# TELEDYNE CONTINENTAL<sup>®</sup> AIRCRAFT ENGINE MANDATORY SERVICE BULLETIN

**SUBJECT: MAGNETO TO ENGINE TIMING**

## Category 1 MSB94-8C

**SUPERSEDES MSB94-8,  
MSB94-8A, MSB94-8B  
Technical Portions FAA  
Approved**

**FIGURE 1.**

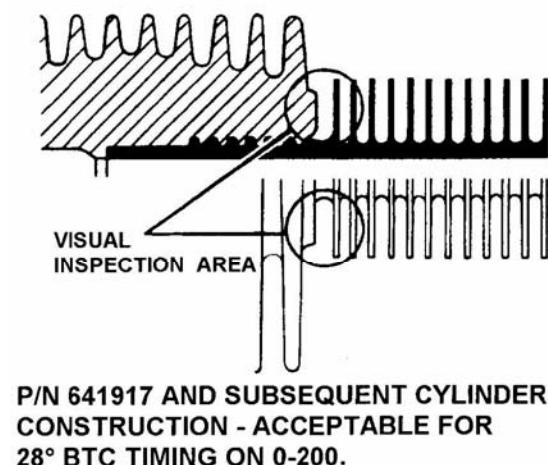
- B. To provide O-200-A and -B engine models that are eligible for magneto timing advance. See timing table Note 5 and Figures 1 and 2.

- [5] O-200-A and -B model engines that have a complete set (4 each) of P/N 641917 or subsequent (higher) part number cylinders installed are eligible to have the timing advanced to 28 degrees BTC. This may include a combination of 641917, 649543, 653246, 654377, 653816, 655483 or subsequent (higher) part number cylinders. The cylinders P/N 641917 were first produced beginning in 1977. The cylinder part number is stamped on the barrel flange. The absence of a cylinder part number usually indicates cylinders manufactured prior to P/N 641917. Visual acceptance can be determined by the examples listed in FIGURES 1 and 2. For those engine that have the applicable cylinders and timing advanced, restamp the engine data plate to indicate magneto timing of 28 degrees BTC and make a log book entry noting the change and the part number of the qualifying TCM cylinders installed. Subsequent installation of cylinders must be of the part numbers listed above to retain the advanced (28 degree BTC) timing. Only cylinders manufactured by TCM qualify for the advanced timing under this service bulletin.
